Planning Commission Meeting Agenda

Site Plan Review

Site: 27000 Southfield Road – Discount Tire
Applicant: Joseph Westerbeke, PE
Plan Date: 03/19/2021
Zoning: Commercial-Vehicular District, MX- Mixed Use District, Single-Family District
Parcel ID: 24-13-359-007; -016; -052; -054; -061
Status: **READY FOR PLANNING COMMISSION CONSIDERATION**

SITE PLAN REVIEW

SHEET# S-1

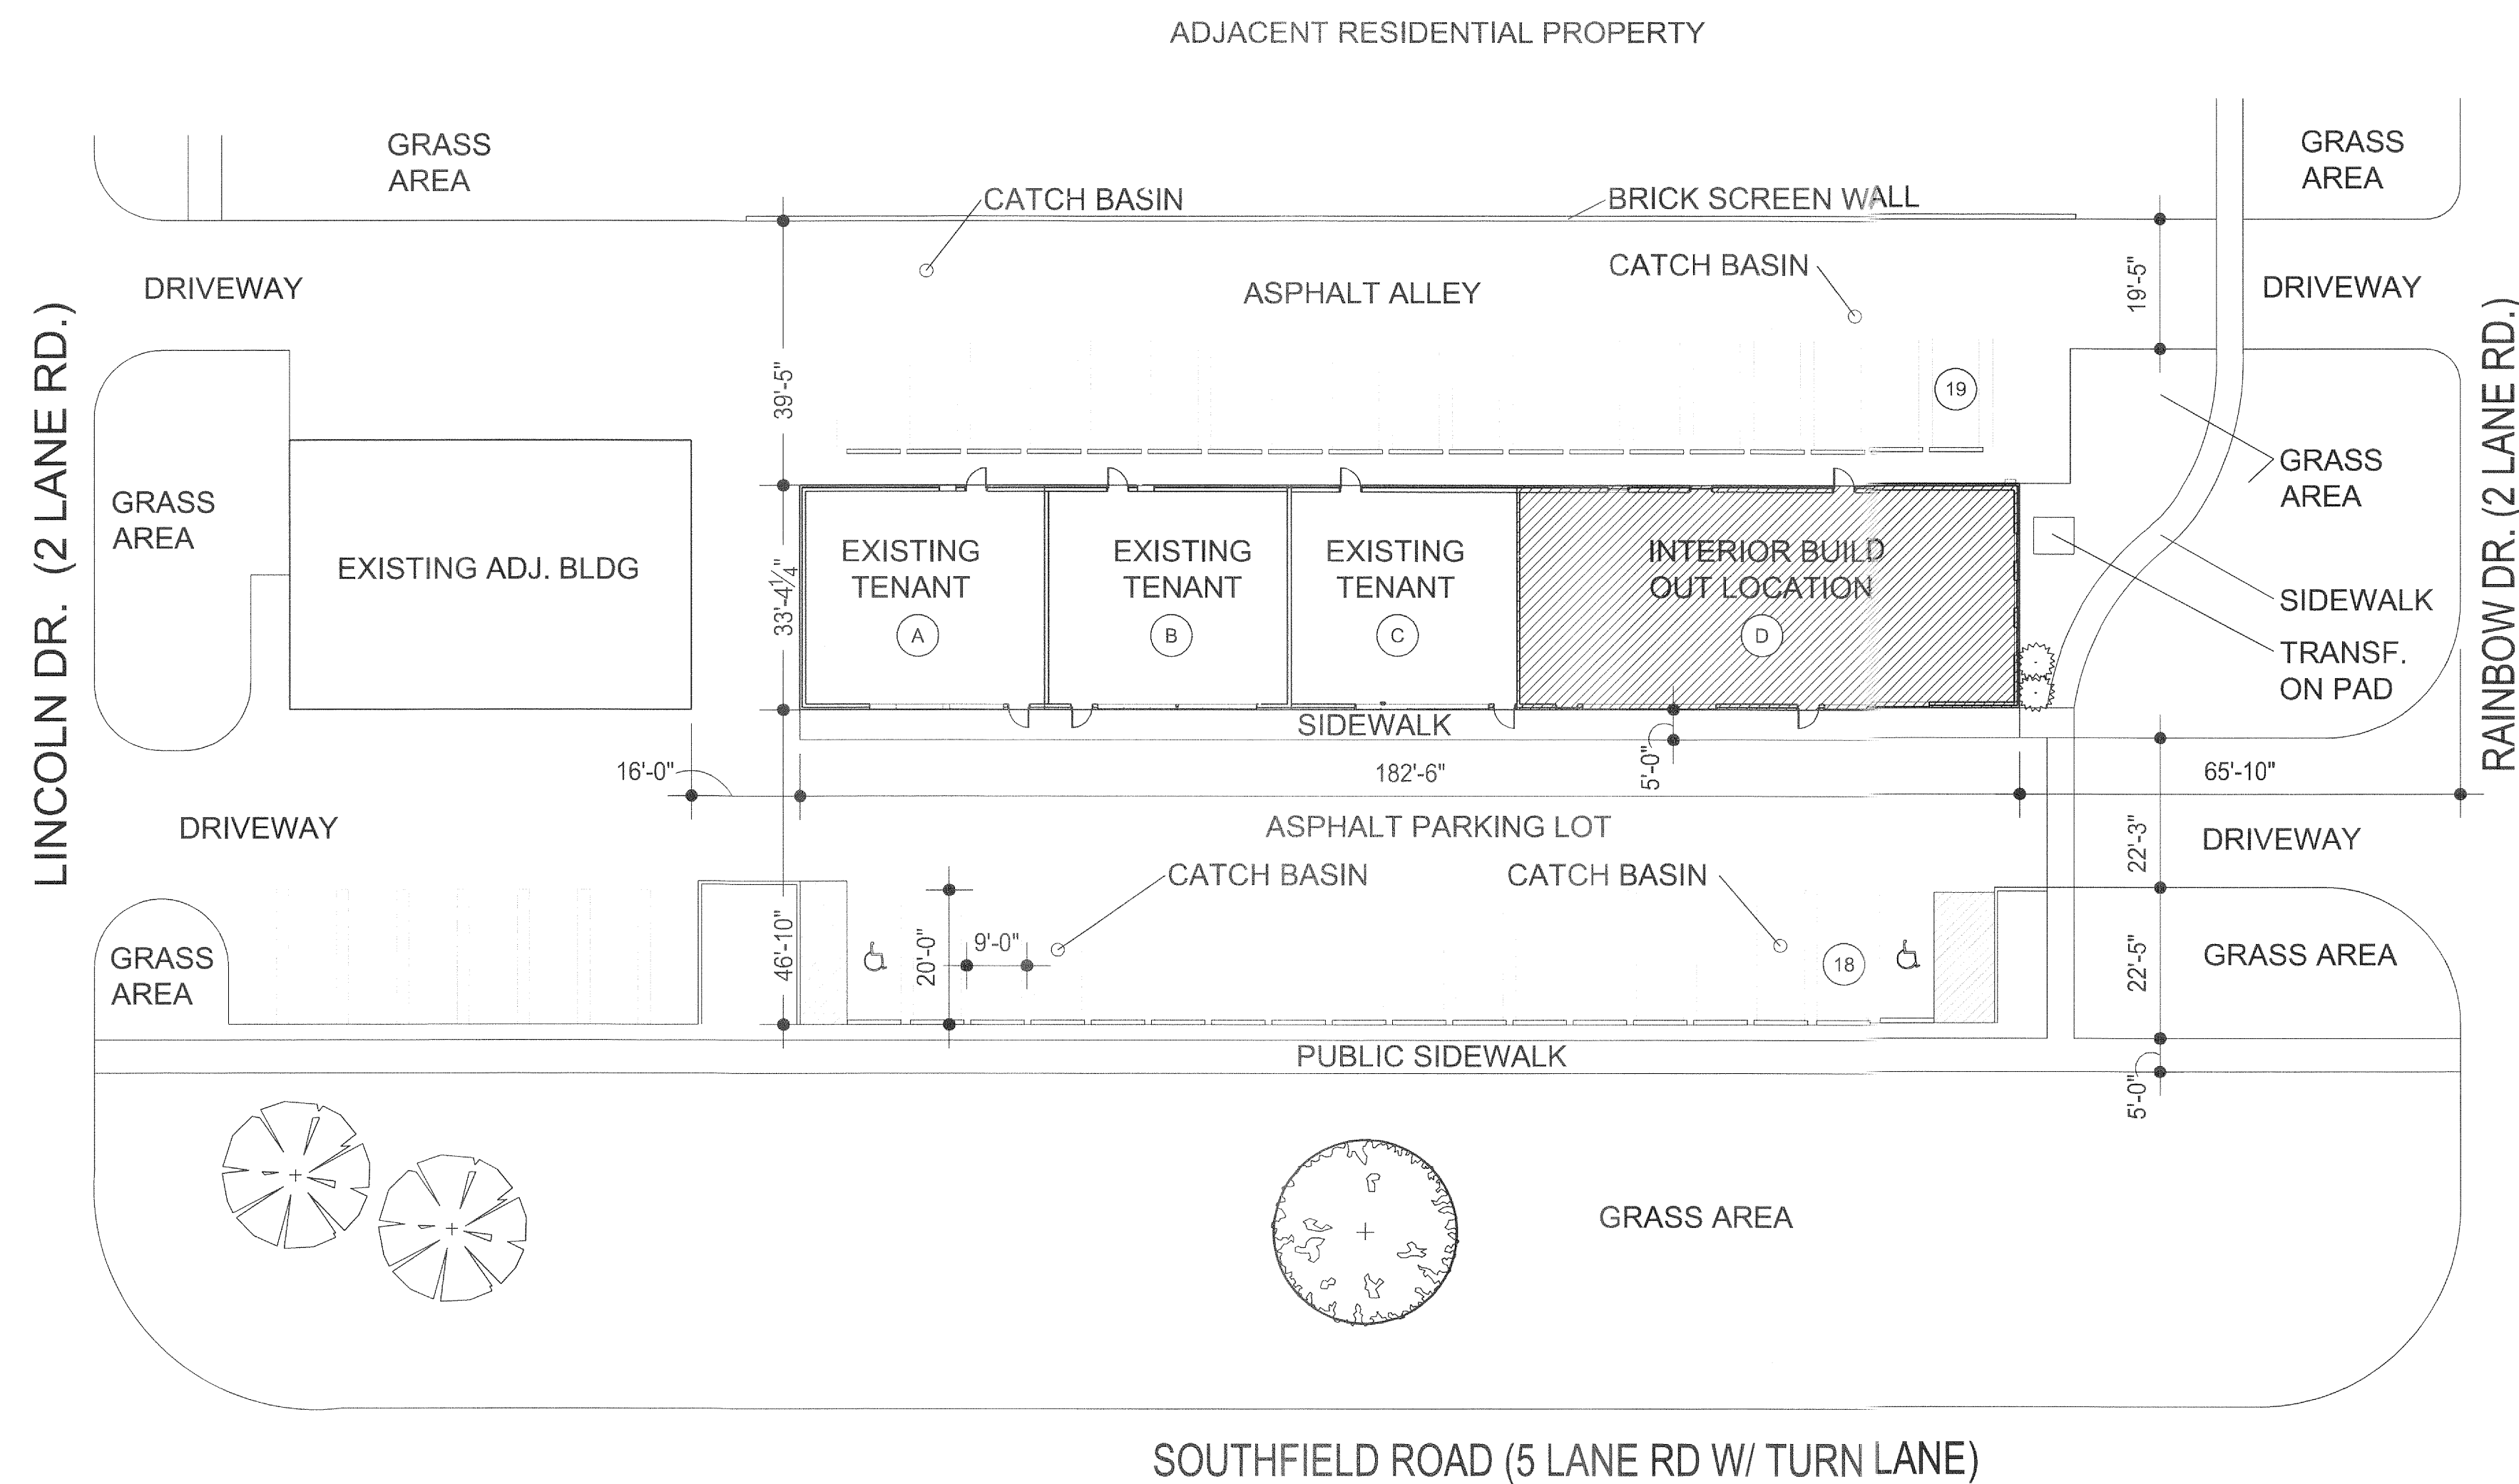
2. **Adjacent land uses.** Properties to the north, south, and east (across Southfield Road) are also zoned MX-Mixed Use District. The site plan labels an existing, paved alley consisting of off-street parking spaces, between the building and adjacent single-family residential property. **The applicant should provide a signed and sealed survey to verify property boundaries. The survey shall also dimension the width of the drive aisle and rear parking spaces in order to confirm the spaces may be utilized for the proposed use, as indicated on the site plan.**

3. **Site configuration and access.** There are currently four commercial driveway curb cuts; two from Lincoln Drive on the south and two from Rainbow Drive on the north that provide vehicular access to the site. There is no direct vehicular access to and from Southfield Road. The site plan labels a rear alley as being an asphalt paved area with parking stalls. The surface parking areas on the front and rear of the lot are designed with 90° spaces. **As an existing condition, the rear spaces appear to be encroaching into the adjacent alley. This will be confirmed with the survey noted above.**

The site plan on the cover page shows 18 spaces in the front along Southfield Road and 19 spaces in the back along the alley, for a total of 37 spaces. As noted above, **a survey is required to confirm that the spaces meet ordinance standards.**

- **A signed and sealed survey is required to confirm the width of the alley and dimensions of the parking spaces. The Planning Commission may consider making this a condition of approval subject to the administrative review of the survey.**

Sheet 3 of 8 (Site Layout)

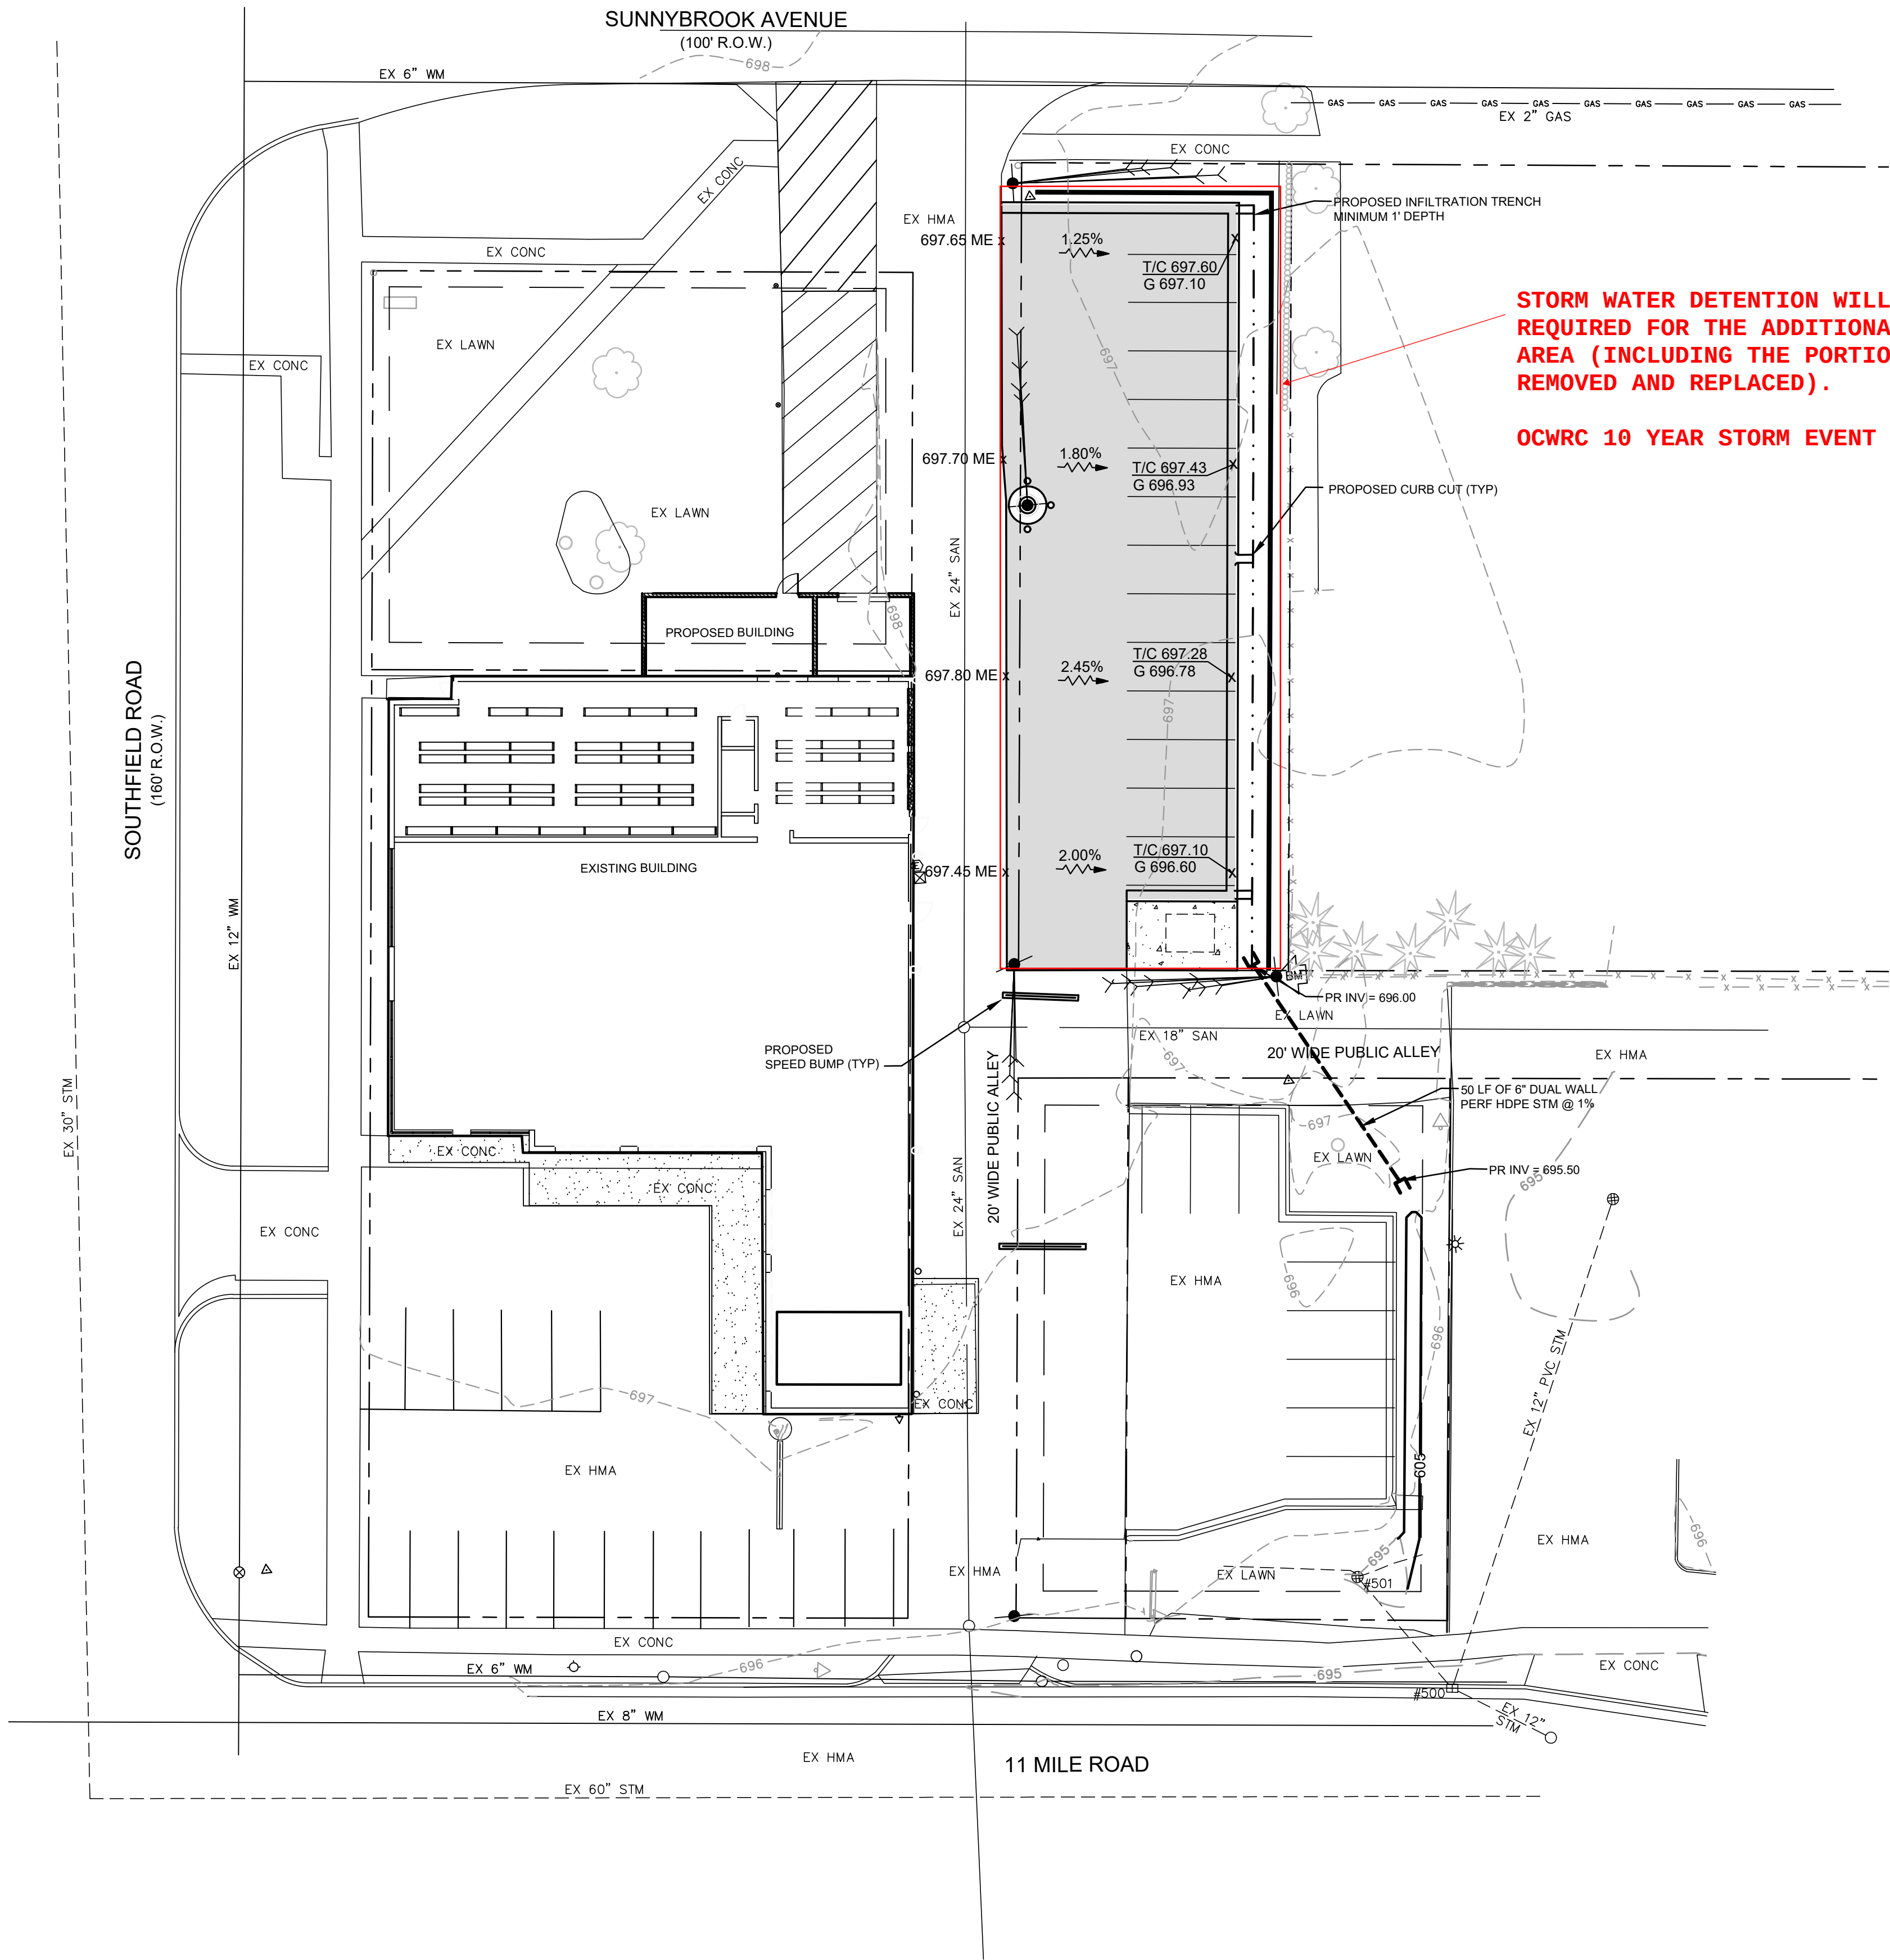
6. **Traffic and Circulation.** In addition to the above required circulation plan, the applicant shall include on the site plan the existing north side of Sunnybrook opposite the site should be shown on the plan. It appears that regardless of whether trucks pull directly into or back into the proposed loading zone, Sunnybrook between Southfield Rd and the loading zone may need to be widened to the south and an appropriate radius added at the loading zone pavement. **As this is a public alley, the applicant should seek permission from the City to add speed bumps as shown.**

- 5.3.3.C. Location..** Dumpsters shall comply with the setback requirements for the district in which they are located. Dumpsters shall be located as far as practicable from any adjoining residential district. The proposed dumpster enclosure is approximately 5' from the adjacent single-family lot. **The applicant shall provide the setback dimension on the site plan.**

9. **Protective or Barrier Screen Wall.** Section 5.5 of the zoning ordinance outlines barrier wall requirements for CV lots that abut residential (R-1 or R-2) lots. The proposed wall is 6' high and 12" thick, as shown in the diagram below, which meets the requirements of this section. The plans indicate an 8' barrier wall exists along the adjacent R-1 lot's southern property line, shared with the east-west alley. However, the wall terminates short of tying into the proposed barrier wall along the lot's western boundary. **The Planning Commission may consider requiring the two walls connect at the adjacent R-1 lot's southwest corner to fully screen the residential property from the abutting commercial development (5.5.4).**
